# Economic and Social Council

### World Forum for Harmonization of Vehicle Regulations

#### Working Party on General Safety Provisions

## Report of the Working Party on General Safety Provisions on its 101<sup>st</sup> session (18–21 October 2011)

Figure 1

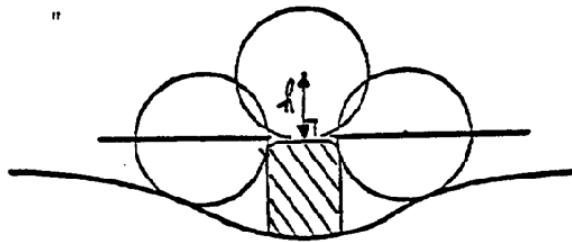
*Insert new paragraphs 6.1.1.4. to 6.1.1.4.2., to read (including the addition of a new figure 1):*

- "6.1.1.4. The requirements in paragraphs 6.1.1.2. and 6.1.1.3. shall not apply to parts of the external surface which protrude less than 5 mm, but the outward facing angles of such parts shall be blunted, save where such parts protrude less than 1.5 mm. For determining the dimension of the projection, the following method shall apply:

- 6.1.1.4.1. The dimension of the projection of a component which is mounted on a convex surface may be determined either directly or by reference to a drawing of an appropriate section of this component in its installed condition.

- 6.1.1.4.2. If the dimension of the projection of a component which is mounted on a surface other than convex cannot be determined by simple measurement, it shall be determined by the maximum variation of the distance of the centre of a 100 mm diameter sphere from the nominal line of the panel when the sphere is moved over and is in constant contact with that component. Figure 1 shows an example of the use of this procedure.

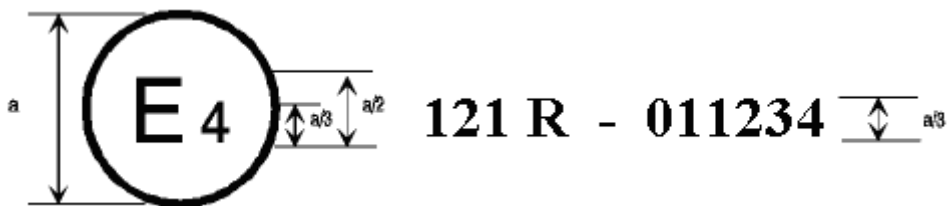
*Table 1*, amend to read (existing footnote 17/ remains unchanged):

No.	Column 1	Column 2	Column 3	Column 4	Column 5
	ITEM	SYMBOL <u>2/</u>	FUNCTION	ILLUMINATION	COLOUR
...	...	...	...	...	...
43.	Electronic stability control	 or ESC <u>17/</u>	Tell-tale	Yes	<b>Yellow</b>
44.	Electronic stability control system "OFF"	 OFF or ESC OFF <u>17/ 20/</u>	Control	Yes	
			Tell-tale	Yes	<b>Yellow</b>

Add a new footnote 21/, to read (the letters "OFF" and "ESC OFF" shall be kept in English and shall not be translated):

**"21/ The supplementary letters "OFF" may be positioned on or adjacent to the outline of the symbol of item No. 43. The font of the letters "OFF" or "ESC OFF" is not intended to be restrictive."**

Model B

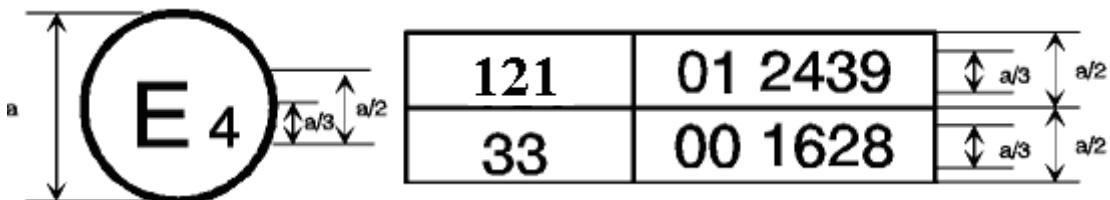
Annex 2, approval mark models A and B, amend to read (existing footnote <sup>1</sup> remains unchanged):

The above approval mark affixed to a vehicle shows that the vehicle type concerned has been approved in the Netherlands (E4) pursuant to Regulation No. 121 and Regulation No. 33<sup>1</sup>. The approval number indicates that, at the dates when the respective approvals were **granted in accordance with** Regulation No. 121 **as amended by the 01 series of amendments and with** Regulation No. 33 **which** was still in its original form."
